Technische Information*Technical Information***13/2016****911 GT3 Cup****Polster Überrollkäfig***Roll Cage Padding***Fahrzeug / Vehicle:****911 GT3 Cup****Bauteil / Part:****Polster Überrollkäfig / Roll-Cage Padding****Modell / Model****2013 - 2016 / 2013 - 2016**

Porsche Motorsport informs that following a revision to the FIA safety regulations (Appendix J – Article 253, 8.3.5) 911 GT3 Cup race cars **MUST** be equipped with additional roll-cage padding complying with FIA Norm 8857-2001 Type A.

3. Installation:

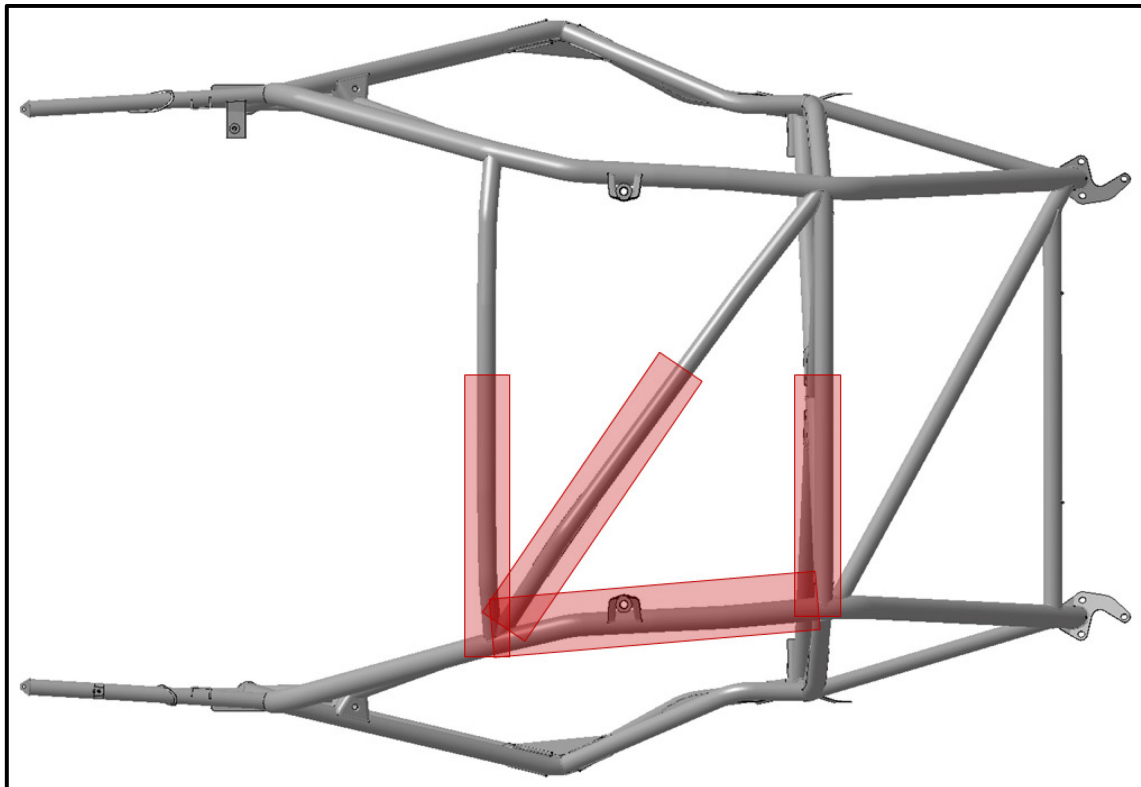
Die folgende Abbildung zeigt die empfohlene Anordnung der einzelnen Polster Elemente (Ansicht von oben). Weiterhin müssen hervorstehende Käfigteile (z.B. Bergeösen) und Verstärkungen gepolstert werden. Die Polster müssen unbeweglich mit dem Käfig verbunden werden (z.B. Kabelbinder).

The following images show the recommended positions and alignment of the individual padding elements (view from above). Additionally, any protruding cage elements such as recovery lugs and strengthening gussets must be padded. The padding must be fixed rigidly to the roll-cage (e.g. cable ties).
